STRENGTHENING DETAILS - 1
BRIDGE NO. LAK-90-2342 R
OVER THE GRAND RIVER

LAK-90-23.42 L&R

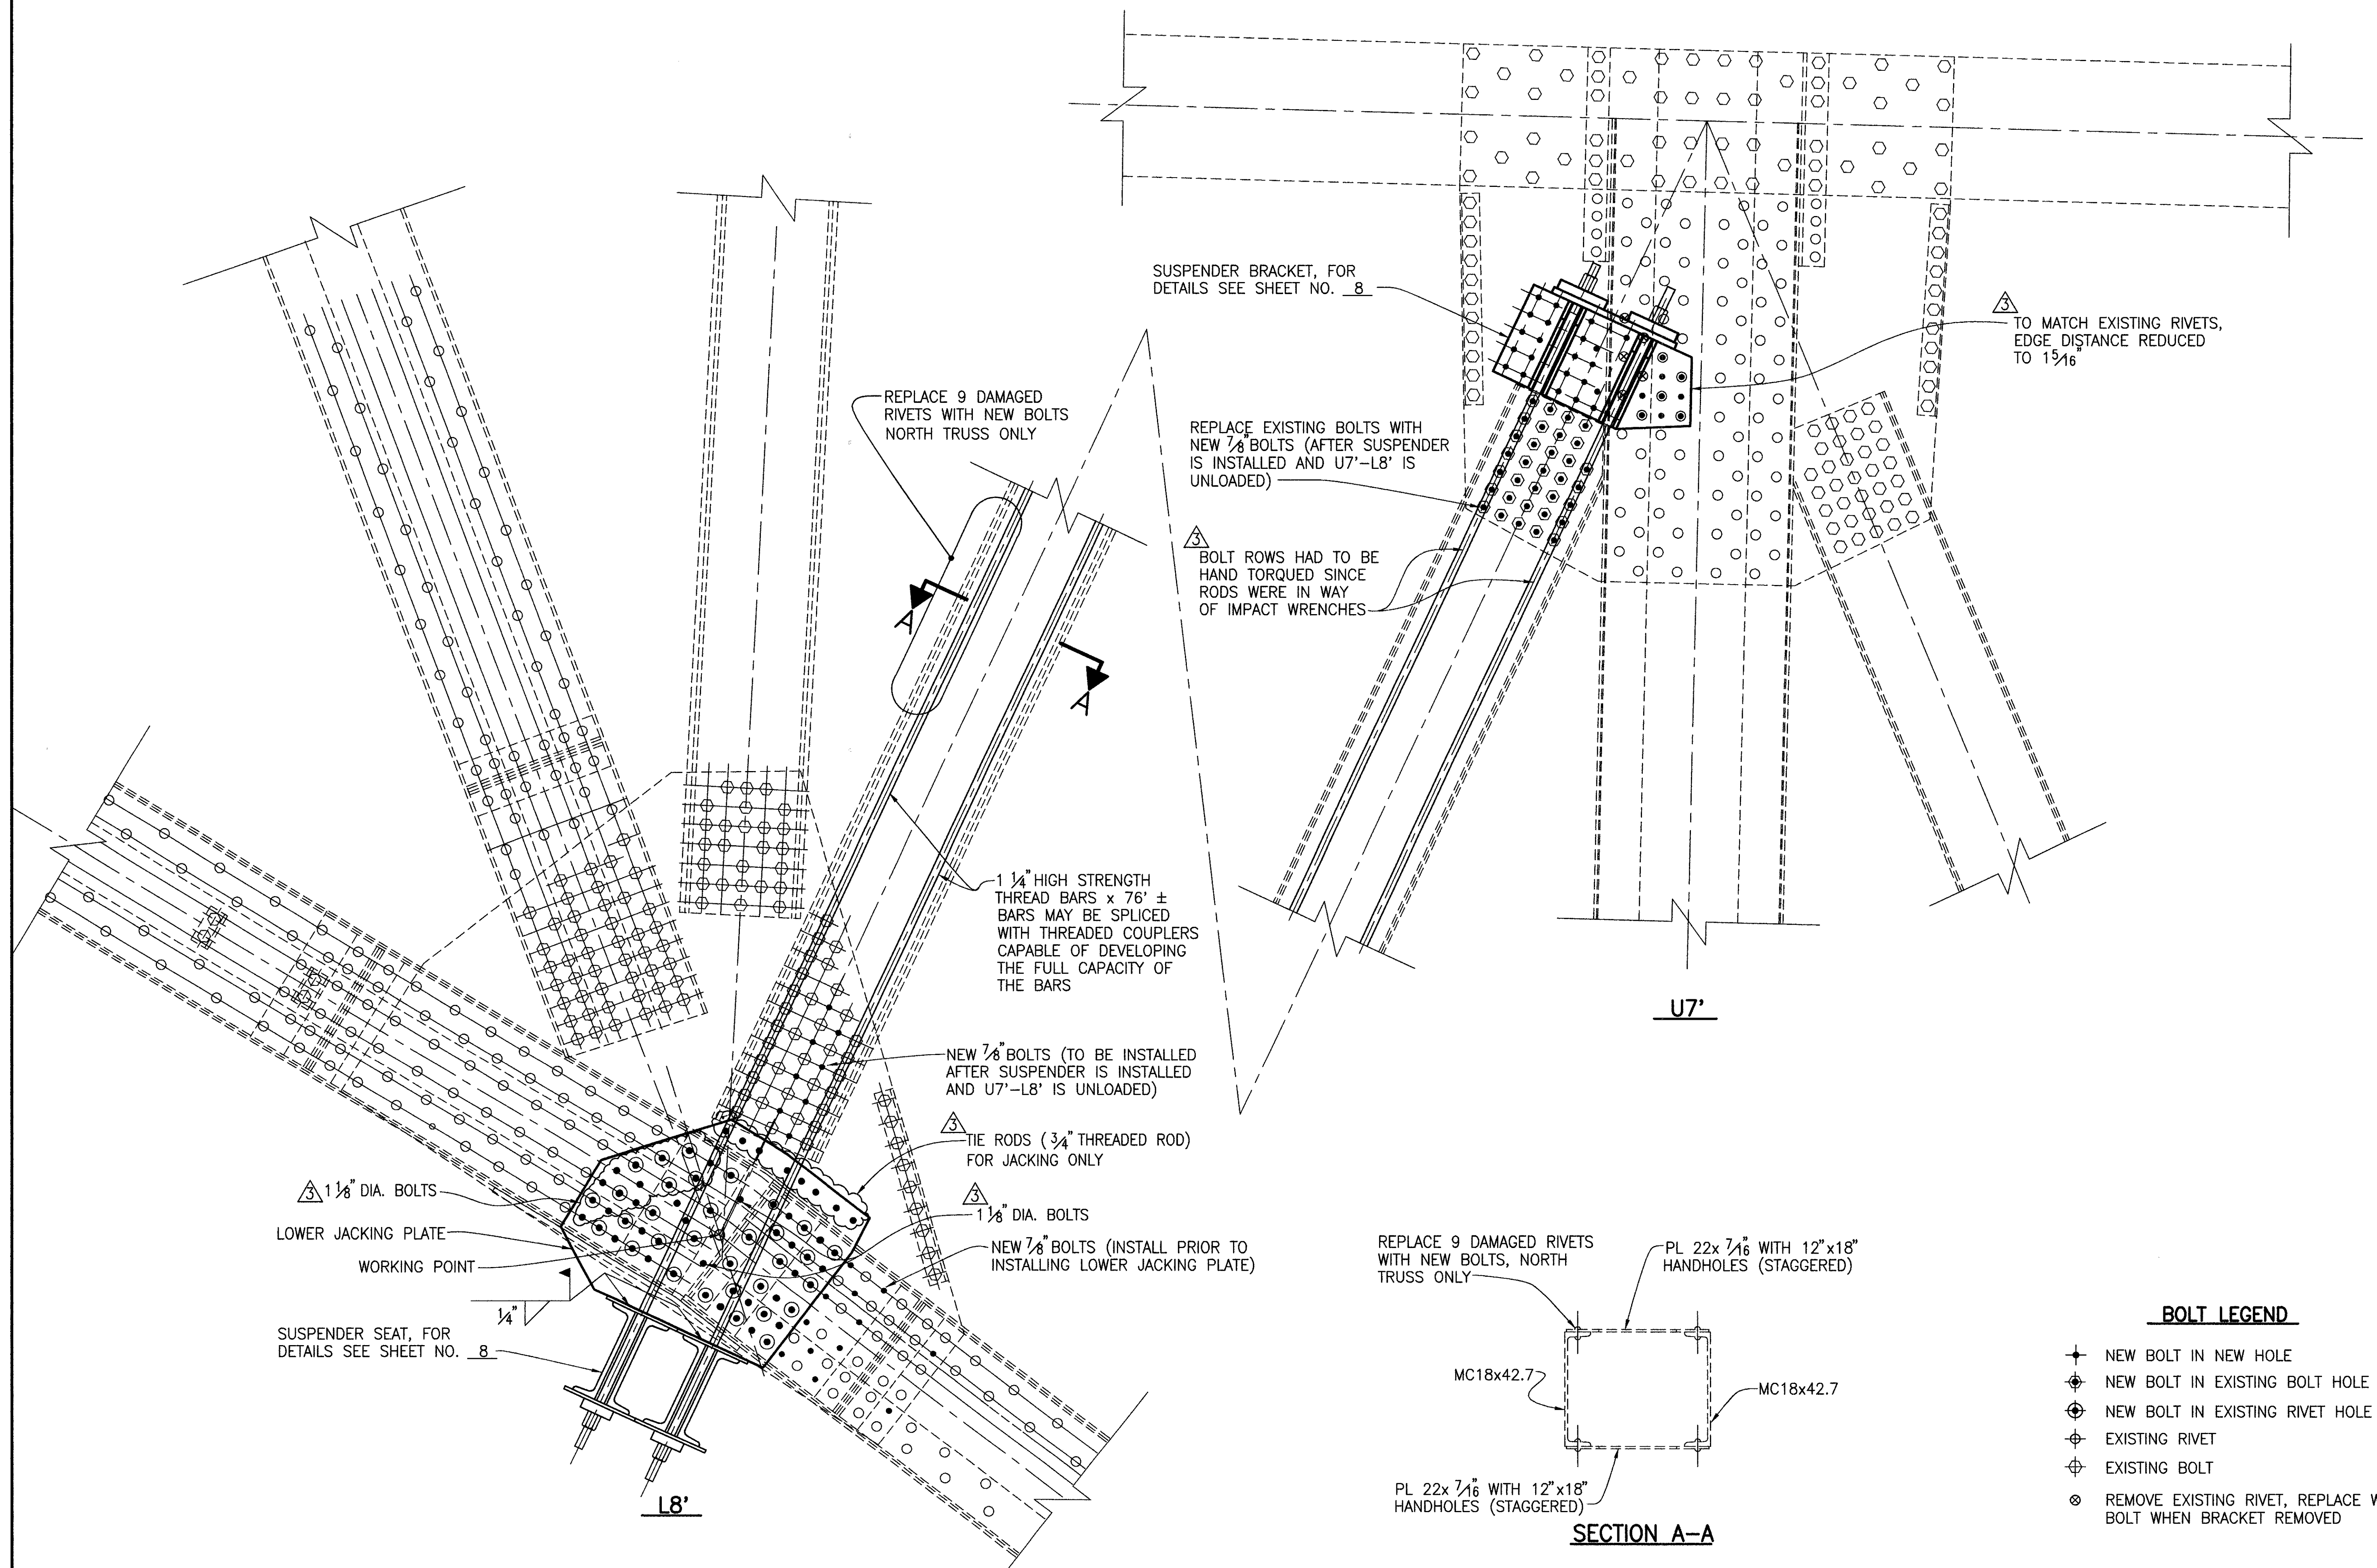
BOLT ROWS HAD TO BE HAND TORQUED SINCE RODS WERE IN WAY OF IMPACT WRENCHES

TO MATCH EXISTING RIVETS, EDGE DISTANCE REDUCED TO 1 5/16"
